Informal document No. **GRSG-87-10** (87th GRSG, 12-15 October 2004, agenda item 8.)

# DRAFT PROPOSAL FOR SUPPLEMENT 5 TO THE 01 SERIES OF AMENDMENTS TO REGULATION No. 46

(Rear-view mirrors)

Transmitted by the expert from the European Commission

Figure 4. Field of vision of Class IV wide-angle mirror for a left hand drive vehicle

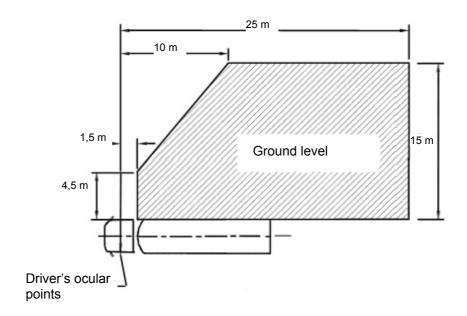
"16.5.4. The field of vision must be such that the driver can see at least a 15 m-wide, flat, horizontal portion of the road, which is bounded by a plane parallel to the median longitudinal vertical plane of the vehicle and passing through the outermost point of the vehicle on the passenger side and which extends from at least 10 to 25 m behind the driver's ocular points. In addition, the road must be visible to the driver over a width of 4.5 m, which is bounded by a plane parallel to the median longitudinal vertical plane and passing through the outermost point of the vehicle starting from a point 1.5 m behind the vertical plane passing through the driver's ocular points (see figure Annex 6, Figure 4)."

In Annex 6, replace Figure 4 by the figure below:
